5.3. RECONFIGURATION OF A LOT – 1 INTO 72 LOTS (PLUS PARK), VIXIES ROAD, WONGA BEACH

Reconfiguring a Lot (1 Lot into 72 Lots) plus Park

That Council approves the development application for Reconfiguring of a Lot (1 Lot into 72 Lots) over land described as Lot 32 on SP126925 located at Vixies Road Wonga Beach, subject to the following:

ATTACHMENT 1 – APPROVED PLANS

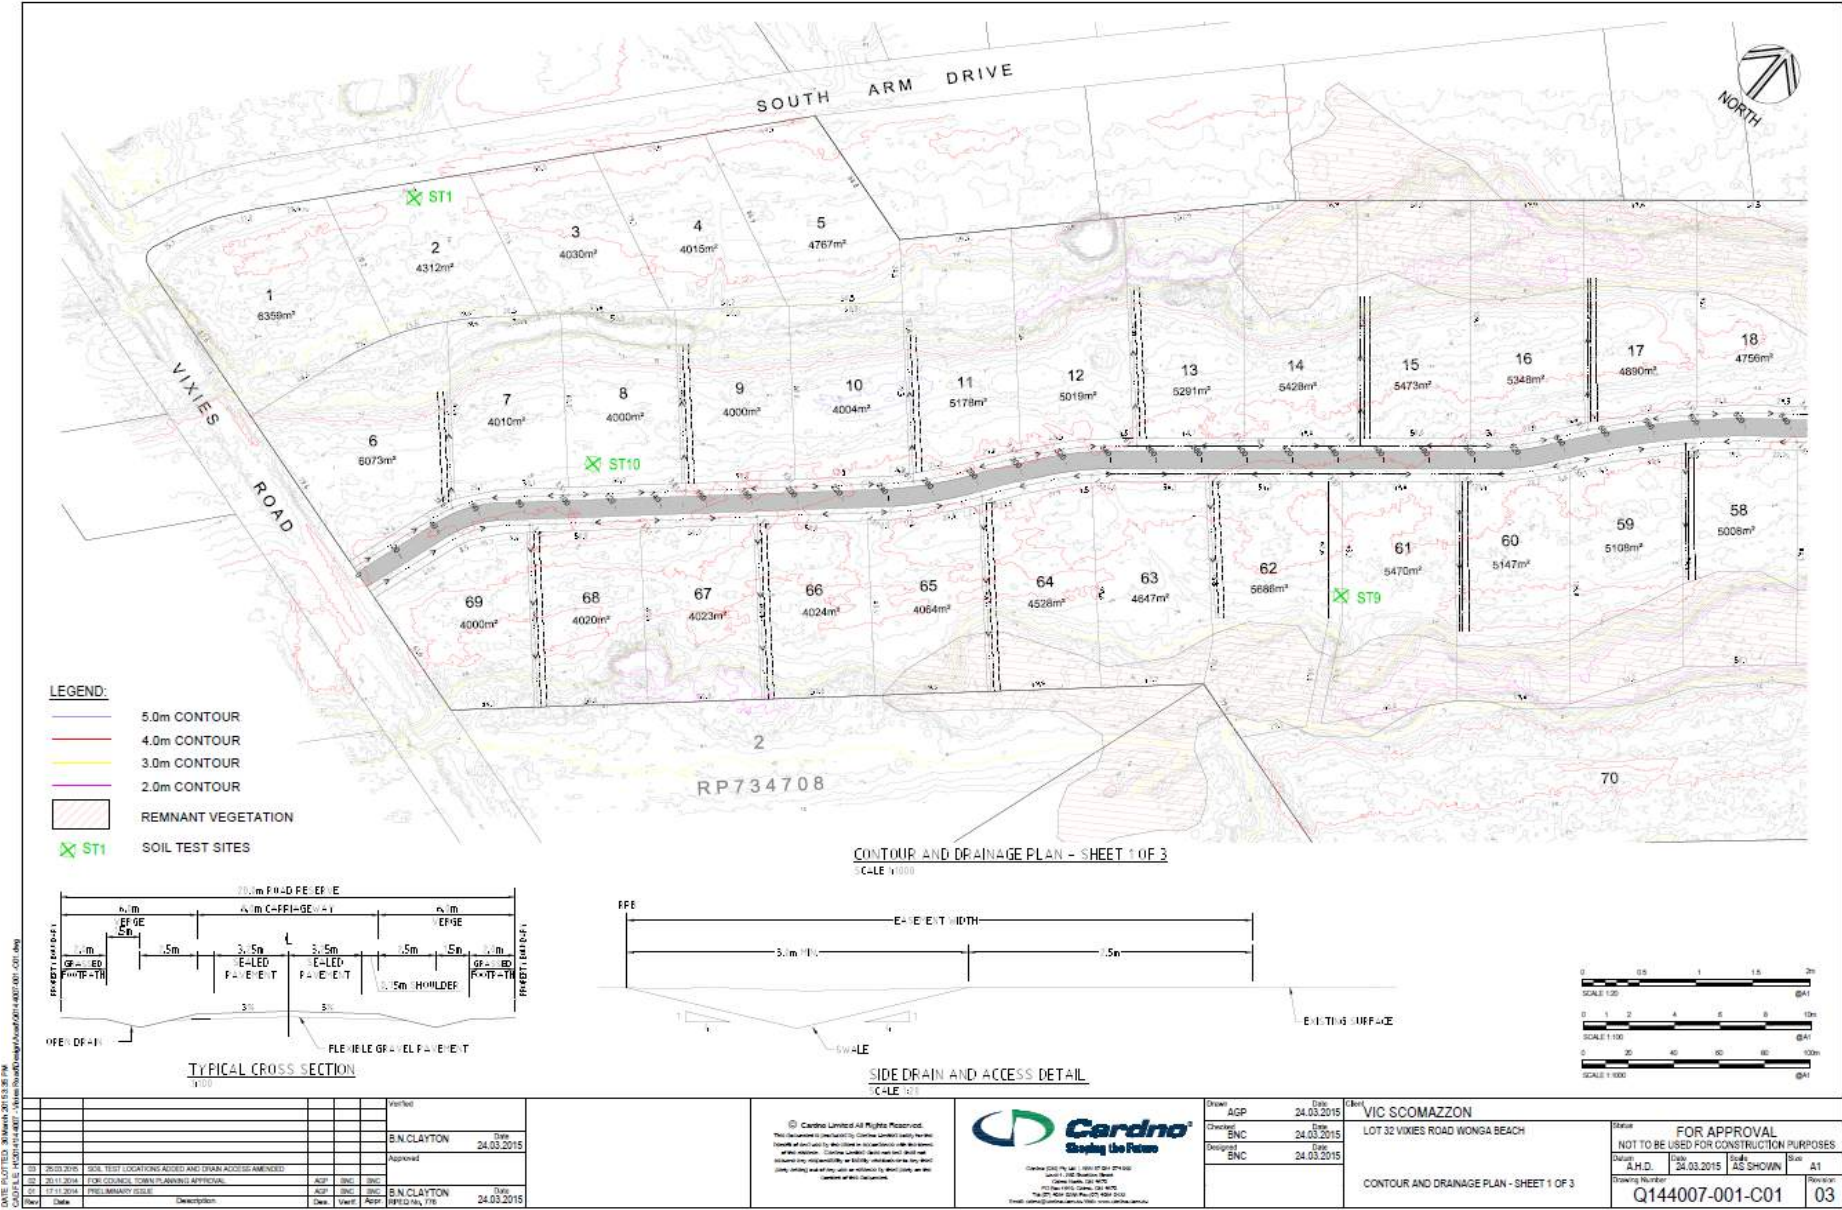
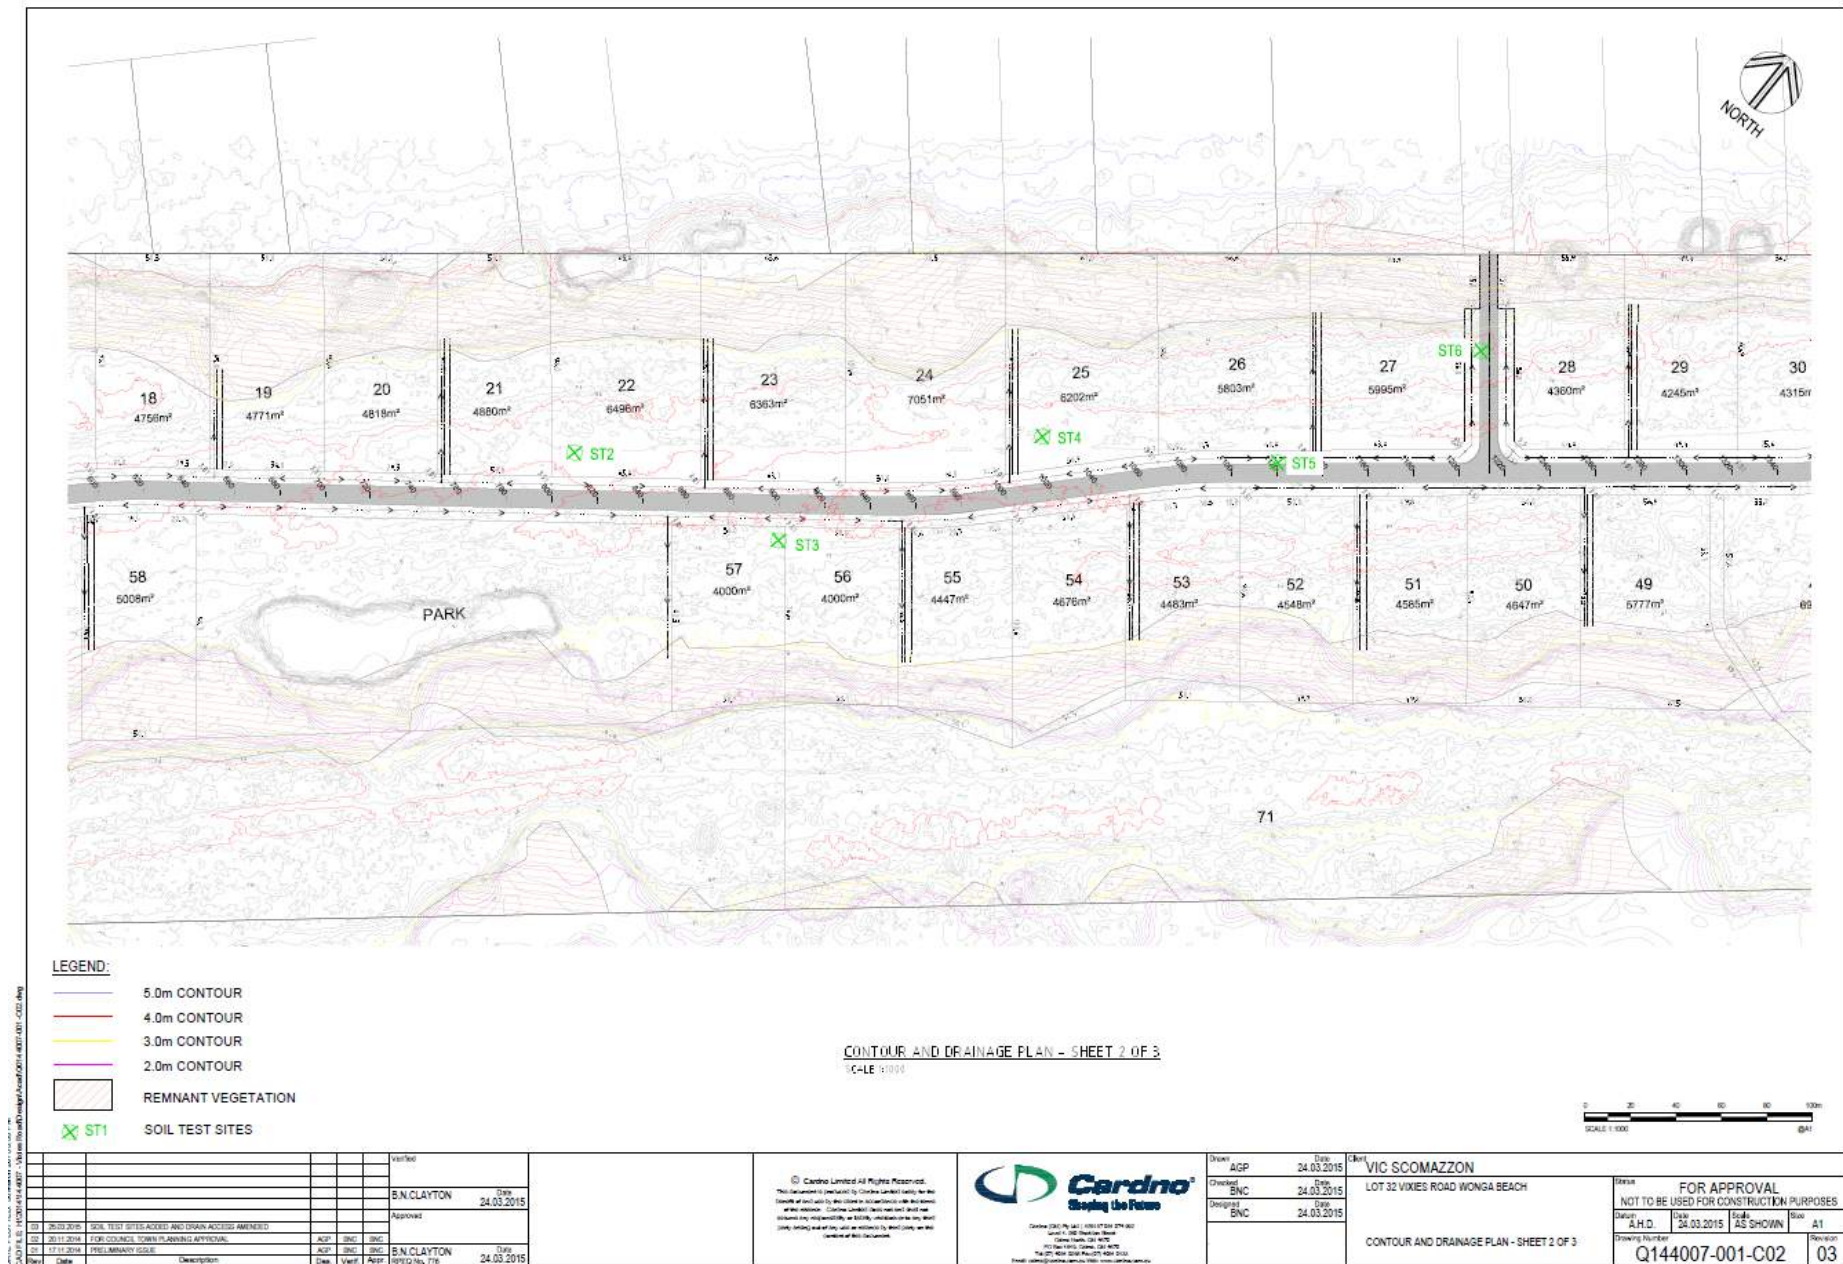
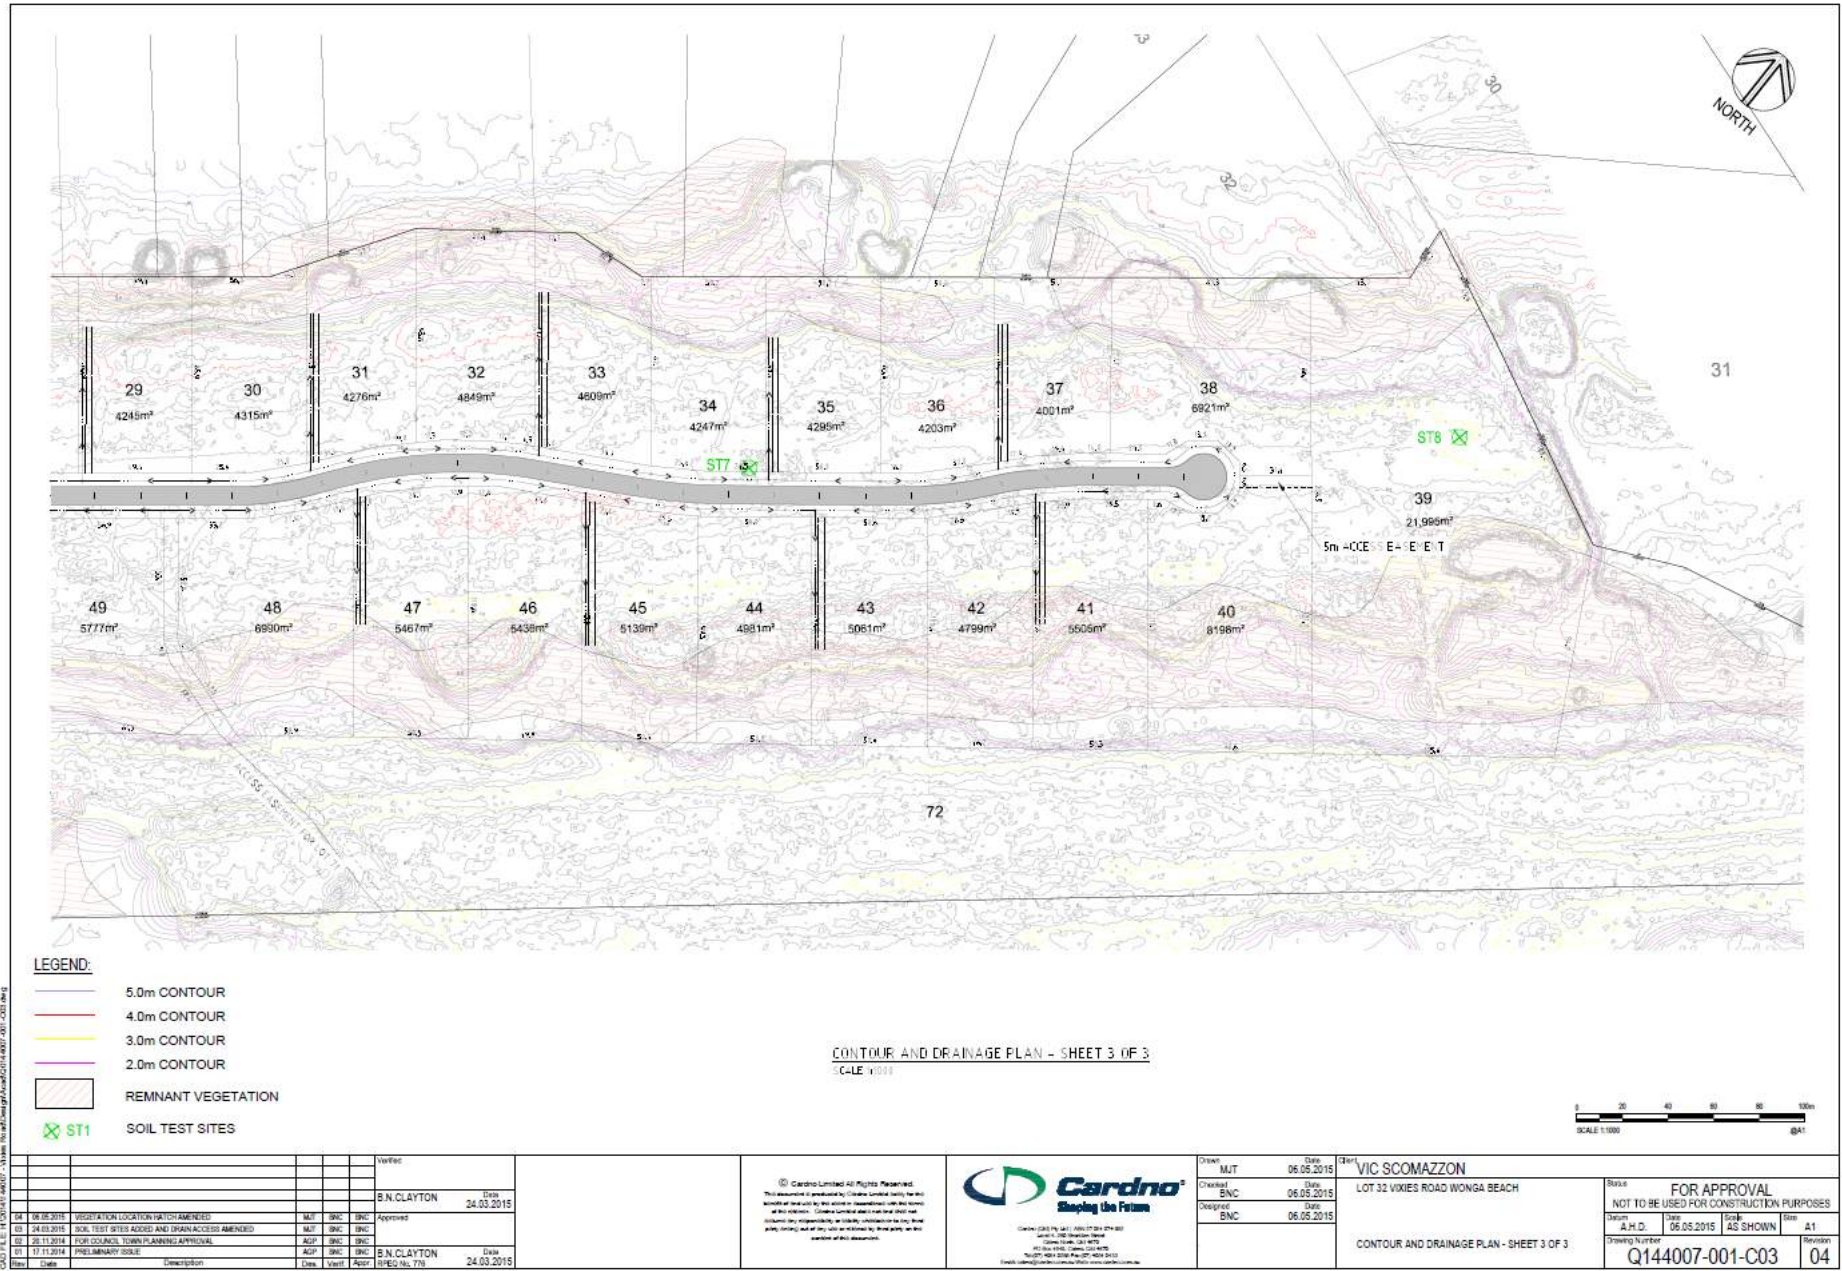
3. The street layout and design is to be generally in accordance with Cardno Drawings Q144007-001-C01 to C03 subject to any amendments to comply with conditions, Queensland Streets and the FNQROC Development Manual, to the satisfaction of the Chief Executive Officer. In particular:

- a. Design and construct the internal road servicing lots 6 to 72 in accordance with the FNQROC Development Manual and generally in accordance with the Cross Section as detailed on Drawing No. Q144007-001-C01 subject to the construction of a 7 metre sealed pavement with 1 metre gravel shoulders.

- b. Design and construct the road connection to South Arm Drive. Lots 27 and 28 are to be amended to ensure the road reserve width is consistent for the entire length of the road. Noting the vegetation constraints in the drainage reserve, the road connection within the drainage corridor is to meet the following performance criteria:

- a. Drainage infrastructure generally in accordance with the concepts shown on Cardno drawings Q144007-001-C01 to C03 Revision 3 & 4 subject to amendments required to comply with the FNQROC Development Manual. Calculations of the sub-catchment discharge and the flow width and depth in roadside drains and easements must be provided prior to the issue of a Development Permit for Operational Works. The calculations must demonstrate that the flows are fully contained in the drainage paths and do not enter private property except where easements exist;

11. The area identified as Park on Drawing No. Q144007-001-C02 / 03 is not suitable to be dedicated as Park due to the characteristics and location of the land. The land could form one additional residential lot within the development.

An amended plan incorporating the above requirements must be submitted prior to the issue of a Development Permit for Operational Works.

Figure C7

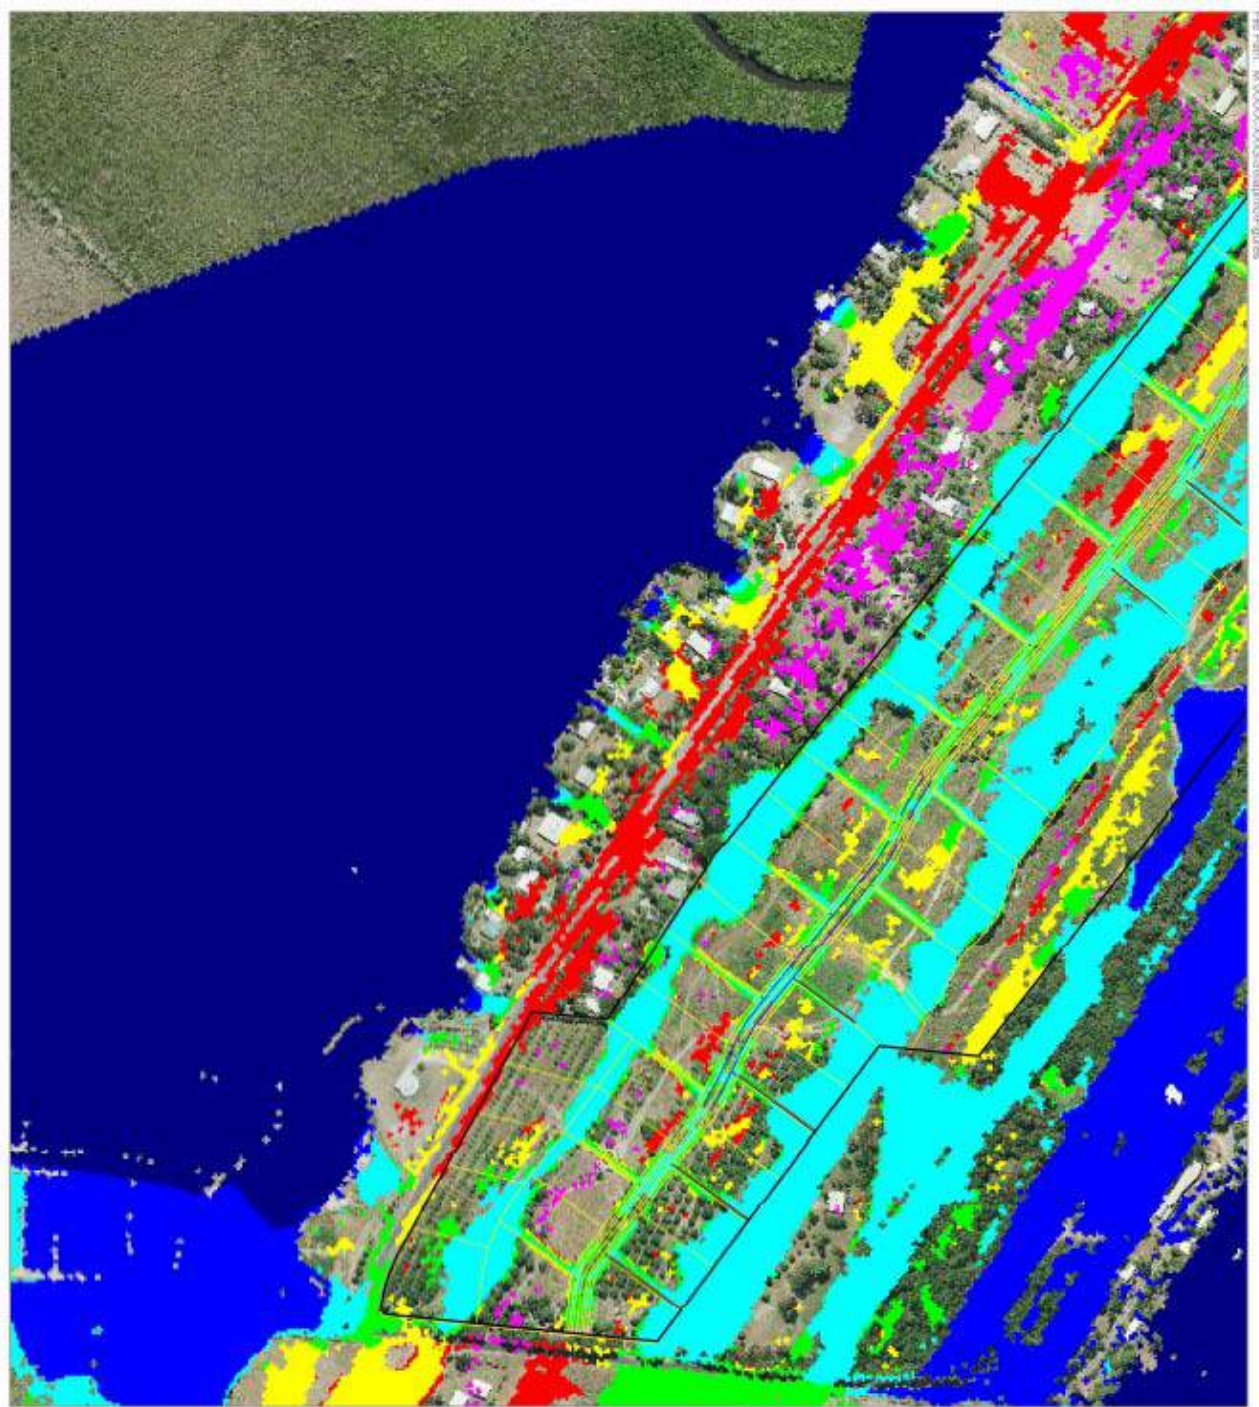
Plans from the flood study for the site illustrating both pre and post development flood levels form Attachment 5. Plans C7 & C8 of Attachment 5 illustrate the extent of flood inundation for the event with the most impact as identified above. It must be noted that these plans represent the Q100 surface level but doesn't provide information on the depth or significance of inundation. To gain an appreciation of these characteristics, refer to Plans C5 & C6.

These plans illustrate flows being largely contained to the drainage swales with isolated and scattered areas of inundation within the proposed lots (excluding the drainage swales). The analysis suggests that the extent of inundation within the lots is less than 250mm and would be reflective of depressions and localised variations in ground levels. Minor earthworks of grading and levelling the land would overcome these issues and therefore are not significant.
